Staff Report

Knoxville Historic Zoning Commission

File Number: 4-C-26-HZ

Location: 1520 Fremont Place **Parcel ID:** 81 L E 045

Various original windows from Redfin real estate listing, 2017

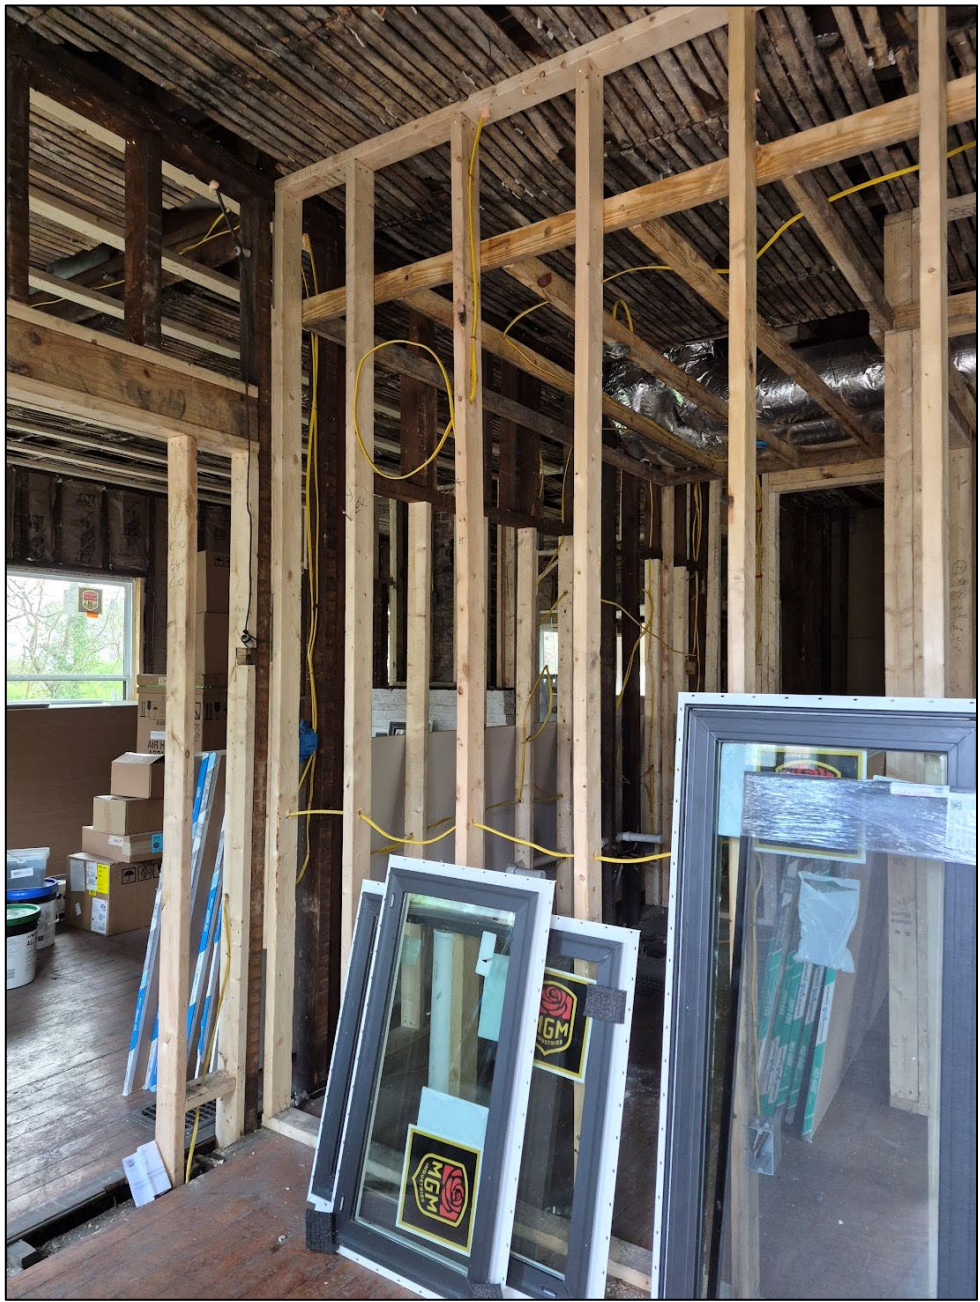
3. The house featured an array of original or historic windows, including multiple 2/2 double-hung wood windows, 3/1 double-hung wood windows, and true-divided light wood casement windows on the front elevation (that may have been a historic modification to the house). The original windows are visible in Google Streetview imagery and the 2017 Redfin real estate listing for the address. No evidence was provided related to the windows’ deterioration prior to their removal and disposal.

6. Guidelines recommend that “if replacement windows are necessary, they shall be the same overall size as the originals, with the same pane division and the same muntin depth, width and profile. They shall be the same materials as the original windows, which were generally wood.” They also require that “true divided lights shall be used in replacement window sashes with more than one pane.” Finally, the guidelines state “windows may not be blocked in. They must retain the full height and width of the original opening.” The installed windows and the completed window enclosures do not meet any of the neighborhood guidelines.

Staff recommends denial with prejudice of the installed windows, enclosed window, removed window trim, and installed siding. The applicant should re-apply to the Historic Zoning Commission with new proposed windows that meet the ONK neighborhood design guidelines, including the window openings that have been enclosed, select a revised design and material for the window trim, and select a new siding material that better reflects the existing. Staff recommends denial of the proposed door.
